To: MODIFIED BY EI 99-022 EFFECTIVE 11/4/99 SUPERSEDED BY EI 02-039 EFFECTIVE 5/8/03		New York State Department of Transportation ENGINEERING INSTRUCTION	EI 97-005
Title: REVISED SPECIFICATIONS FOR ARMOR UNITS (STA-PODS) AND PRECAST CONCRETE HEADWALLS FOR LATERAL OUTLET PIPES			
Distribution: ☐ Manufacturers (18) ☐ Surveyors (33) ☒ Main Office (30) ☒ Consultants (34) ☐ Local Govt. (31) ☐ Contractors/AGC (39) ☒ Regions/Agencies (32) ☐ _____ ()		Approved:  P. J. Clark, Deputy Chief Engineer, Design Division Date <u>2-24-97</u>

Revise the material requirements of two special specifications to reference §704-03 Precast Concrete-General.

PRECAST CONCRETE HEADWALL WITH REMOVABLE RODENT SCREEN
(Not To Scale)

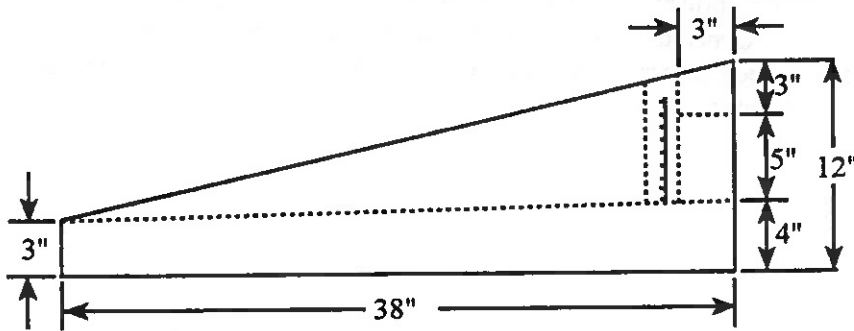
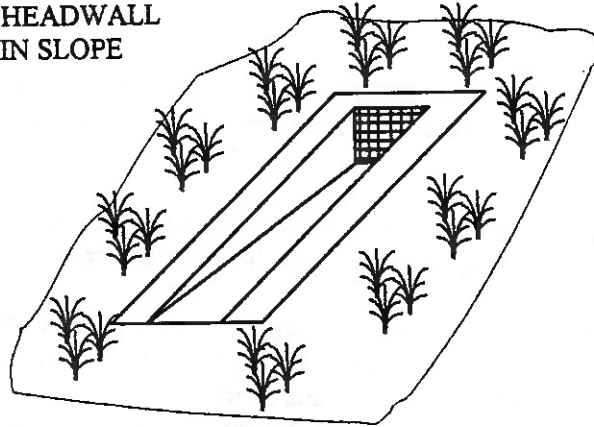
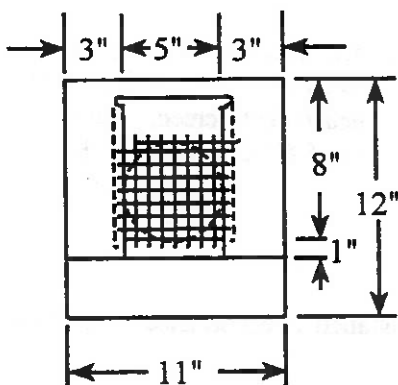
Fabrication - Use the dimensions shown on page 2 of this specification. Proposed changes to these dimensions, other than minor changes approved by the Engineer, require submission of three complete sets of working drawings to the Engineer for review and approval.

Installation - Equip each headwall with a rodent screen of the dimensions shown on page 2 of this specification. Install headwalls flush with the finished slope and orient to allow the headwall apron to drain. Extend outlet pipes into the headwall fitting until flush with the installed rodent screen. Fill the opening between the pipe and the headwall with mortar meeting the requirements of §705-21, Mortar For Concrete Masonry.

PRECAST CONCRETE HEADWALL WITH REMOVABLE RODENT SCREEN
All Dimensions Are In Millimeters (Not To Scale)

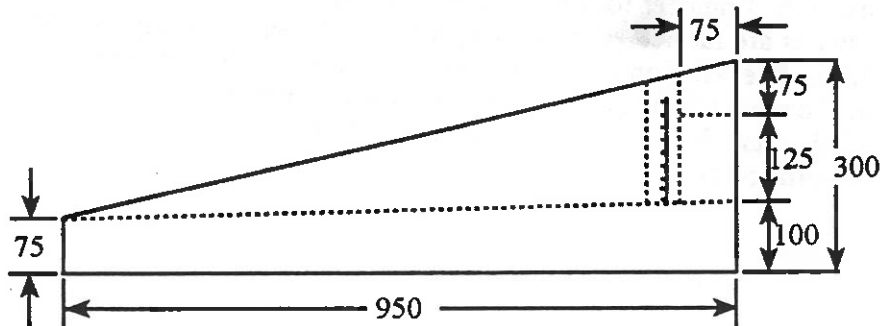
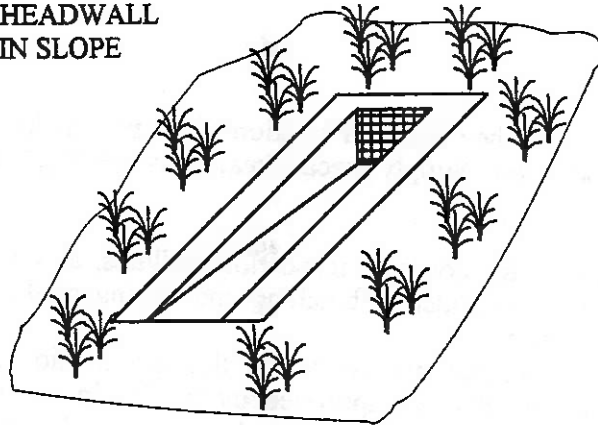
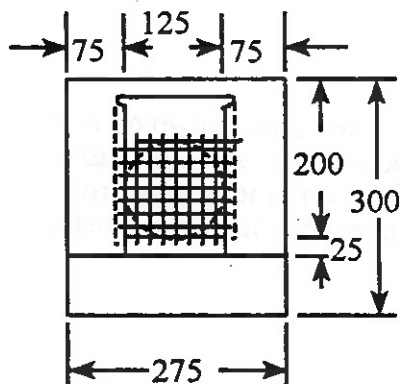
Fabrication - Use the dimensions shown on page 2 of this specification. Proposed changes to these dimensions, other than minor changes approved by the Engineer, require submission of three complete sets of working drawings to the Engineer for review and approval.

Installation - Equip each headwall with a rodent screen of the dimensions shown on page 2 of this specification. Install headwalls flush with the finished slope and orient to allow the headwall apron to drain. Extend outlet pipes into the headwall fitting until flush with the installed rodent screen. Fill the opening between the pipe and the headwall with mortar meeting the requirements of §705-21, Mortar For Concrete Masonry.
